Marked-up Revised Response
to NRC RAI No. 02.05.01-17 (eRAI 6024)

The following revised text in the last paragraph of FSAR Subsection 2.5.1.2.2, Site Area Stratigraphy, and additional paragraphs will be included in a future revision of the COLA.

The following revised text will be included in a future COLA revision to replace paragraphs 7 through 14 of FSAR Subsection 2.5.1.2.4, Site Geologic Hazards.

Figure 2.5.1-352 The two zones of secondary porosity on B-608 (DH) showing the lithology, caliper, natural gamma, velocity (Vs and Vp) and acoustic televiewer logs (5 pages)

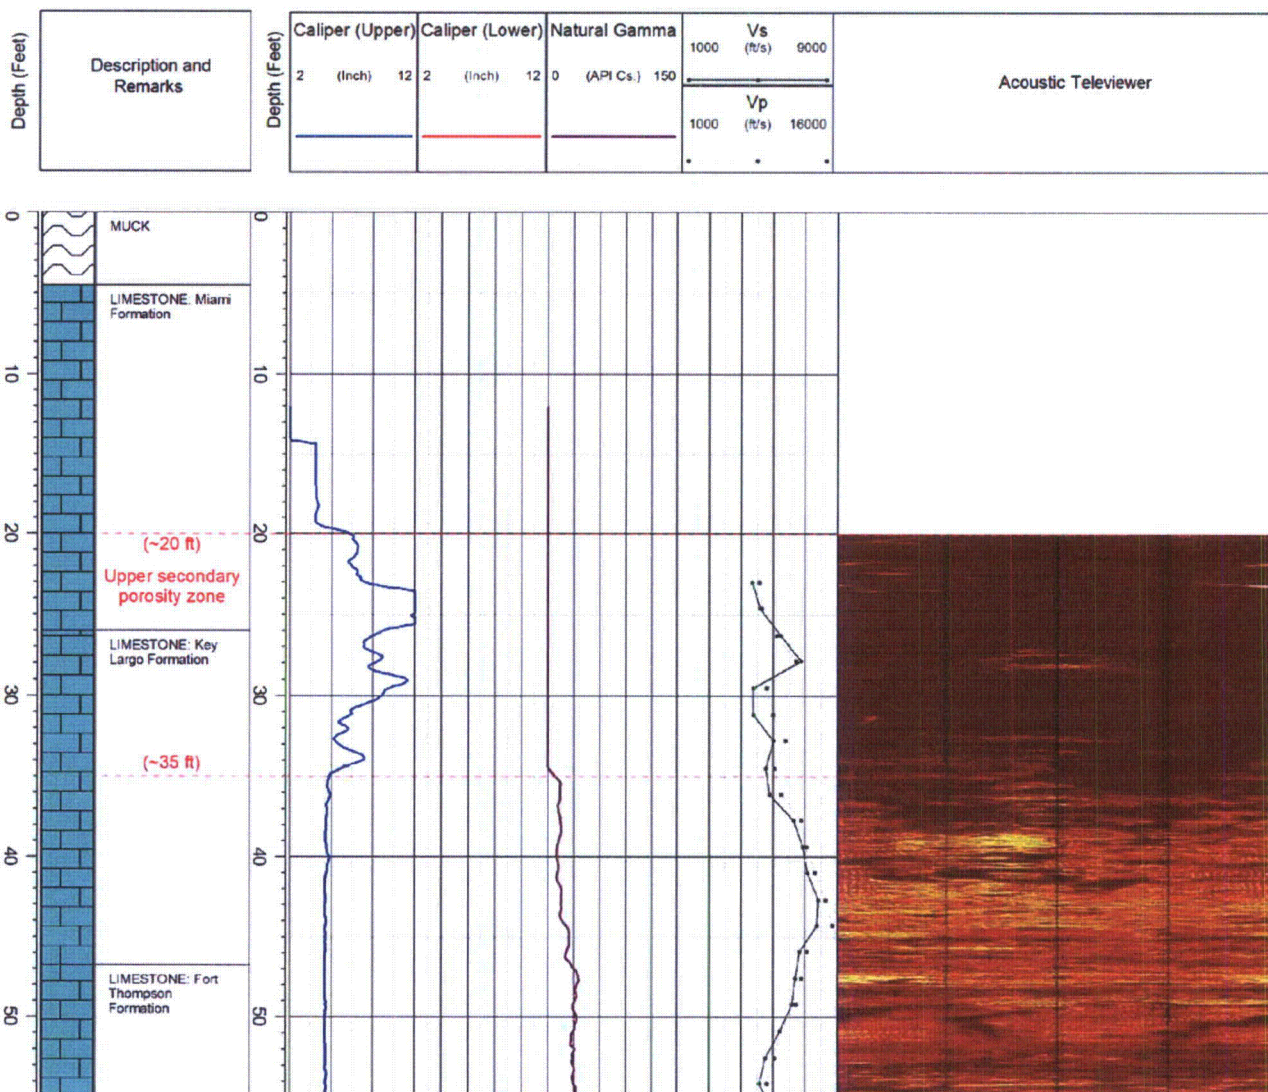
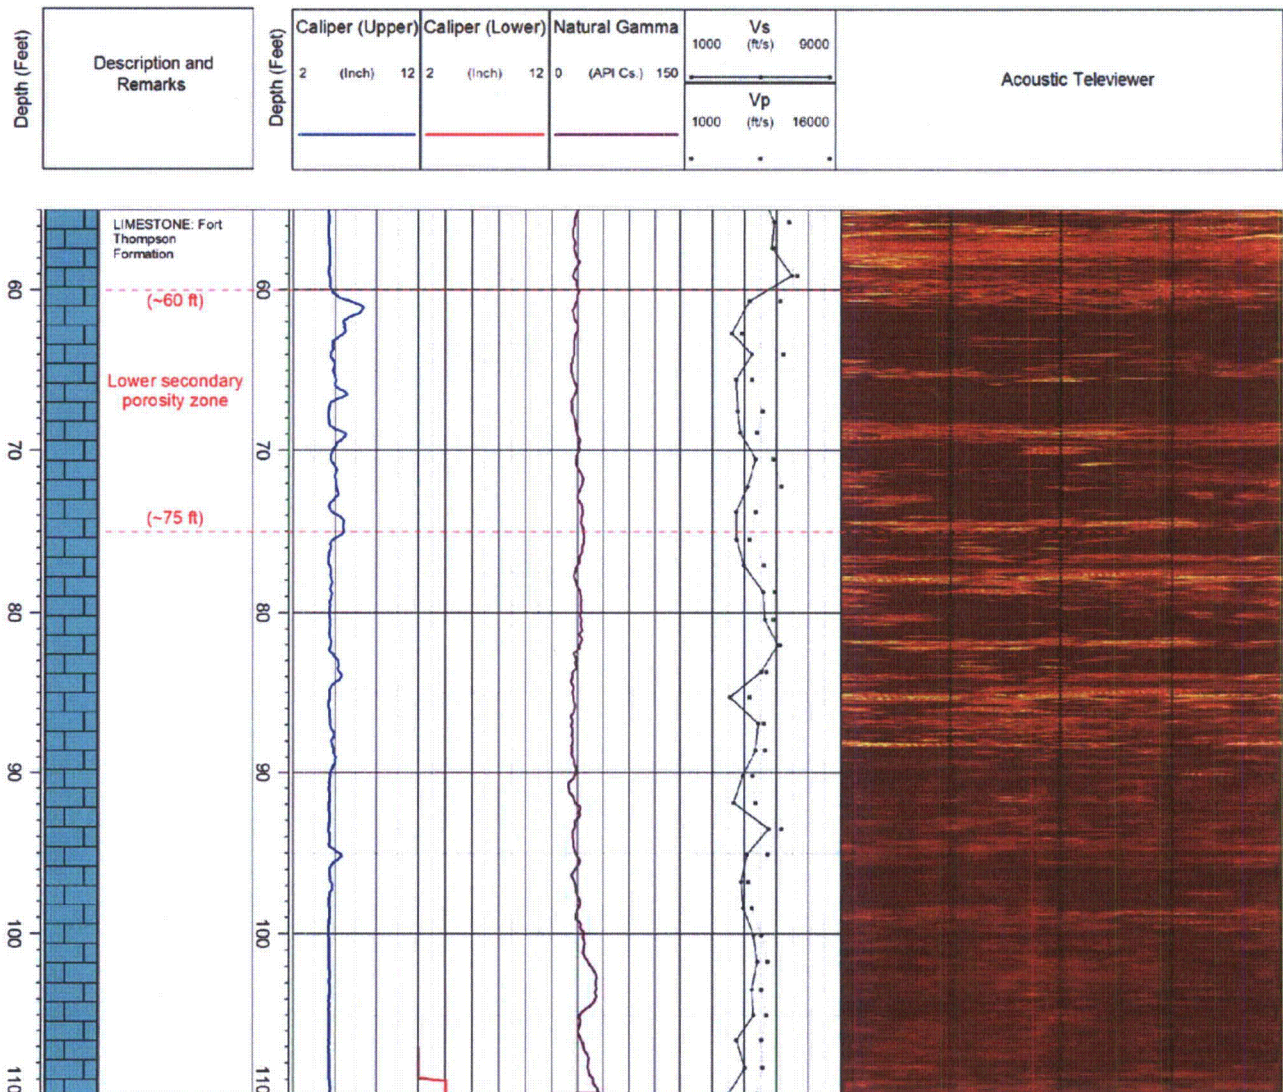
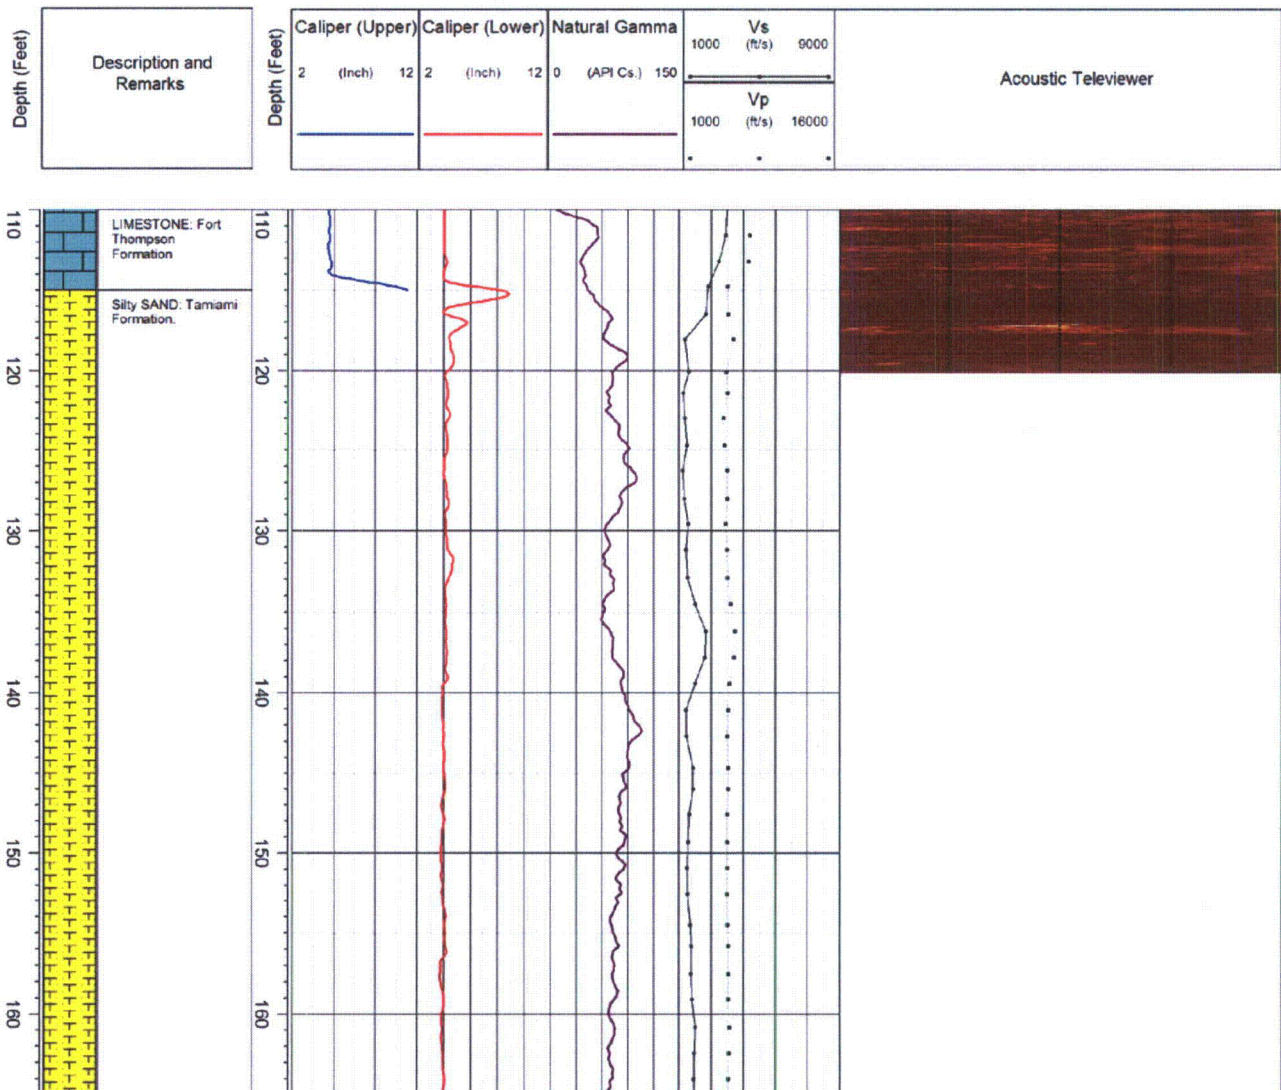
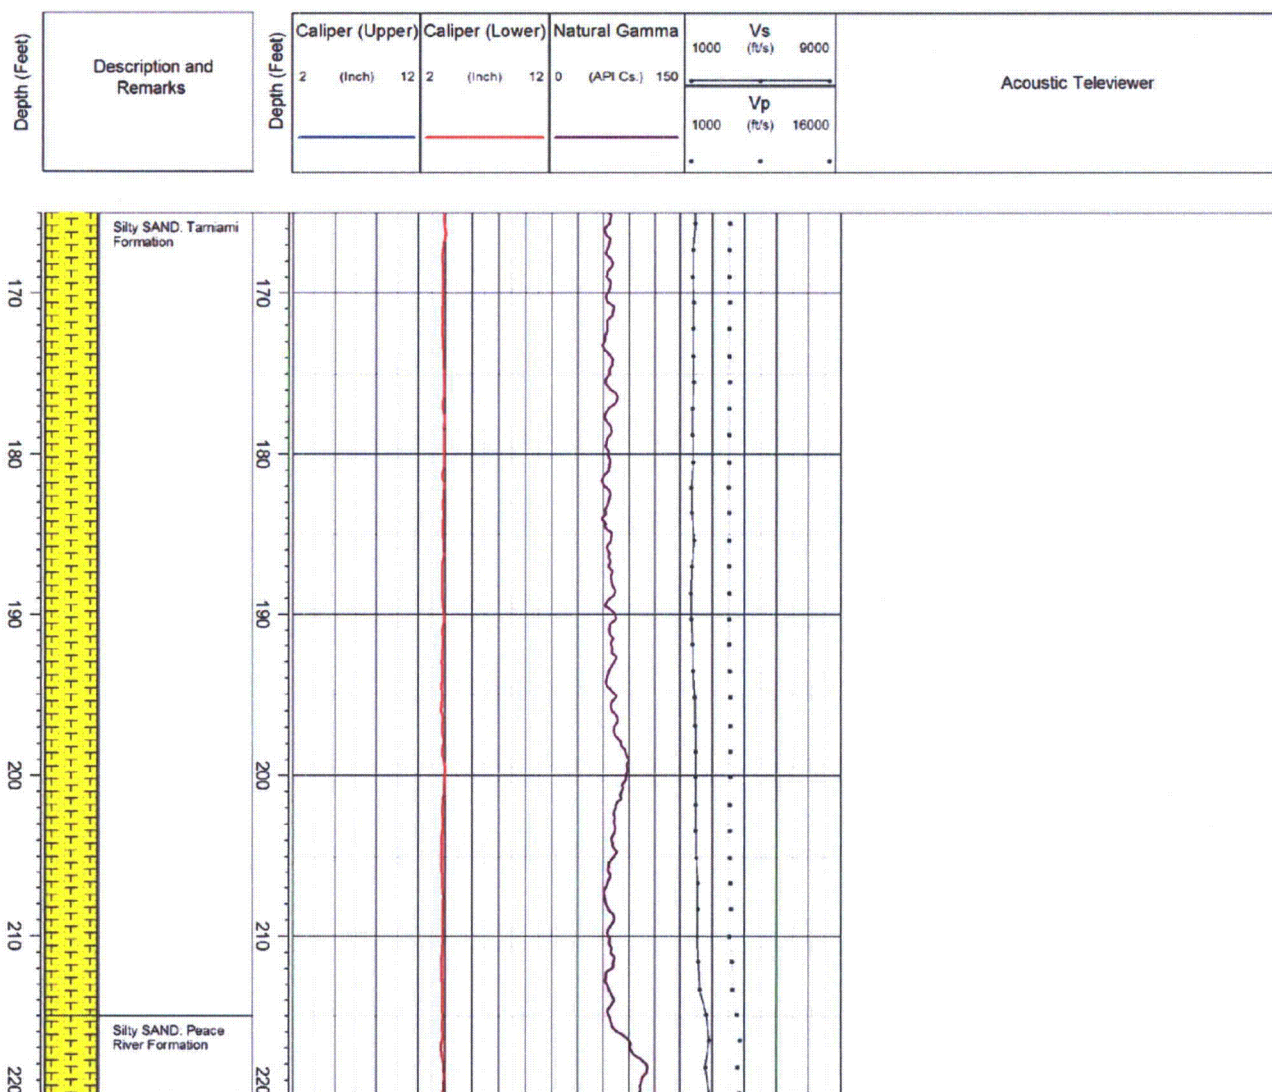
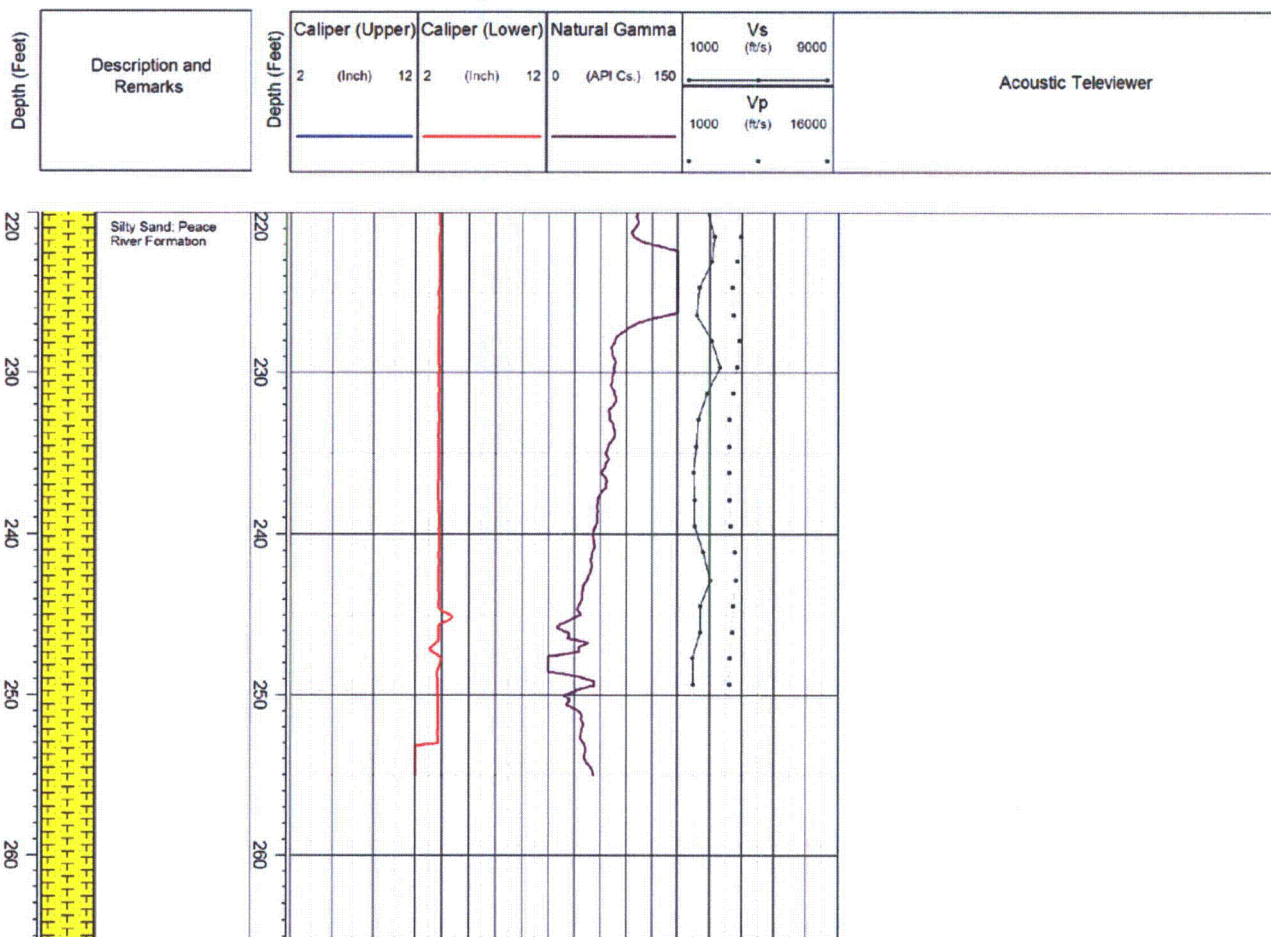
Touching-vug porosity occurs on the site within the approximate depth interval of 20 to 35 feet (Figures 2.5.1-351, 2.5.1-352, and 2.5.1-353) near the contact of the Miami Limestone and Key Largo Limestone (the "Upper Zone" of secondary porosity discussed in FSAR Subsection 2.4.12.1.4). Because the elevation of ground surface at the site is approximately 0 feet NAVD88 (Reference 708), this depth interval corresponds approximately to -20 to -35 feet NAVD88. The origin of this porosity is solution enlargement of burrows, inter-burrow vugs, moldic fossils, root molds, and vugs between root casts (References 404, 723 and 969). These structures are sufficiently numerous and closely spaced so as to form a laterally continuous zone of interconnected voids. Results of drilling and coring within the zone of touching-vug porosity during the site subsurface investigation have shown the feature to be laterally persistent, generally of centimeter scale, with very few indications of possible larger voids such as a rod drop.

Moldic porosity occurs in pockets within the approximate depth interval of 60 to 75 feet (-60 to -75 feet NAVD88) (Figures 2.5.1-351, 2.5.1-352, and 2.5.1-353) in the Fort Thompson Formation and forms the "Lower Zone" of secondary porosity discussed in FSAR Subsection 2.4.12.1.4. The origin of this feature is preferential dissolution of fossil shells and other organic structures rather than the matrix rock within which they are contained, resulting in void spaces of generally centimeter scale within molds of the structures (References 404, 723 and 969).
